INDIVIDUALS

**U.S. Forest Service Non-Compliance With Regulations Concerning
Land And Resource Management Plan Amendments (LRMP).**

Docket No. CP16-10
Mountain Valley Pipeline DEIS

Fig. 4. Chart from Schneising et al. (2014). (Figure and caption copied directly from Figure 7 of their report)

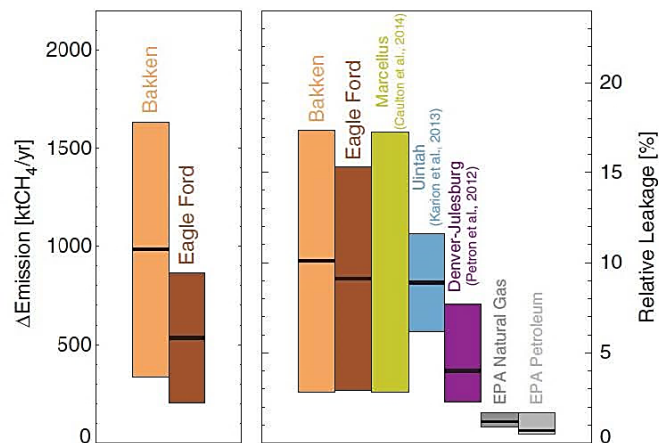
other stages (depending on what operations are occurring in the study region). Those two approaches lead to estimated emissions that can differ by as much as an order of magnitude. Figure 4 below shows some examples of top-down compared with EPA bottom-up estimates. Note that several top-down estimates shown in Figure 4 have a median value of about 10% leakage, compared with the EPA estimate between 1 and 2%.
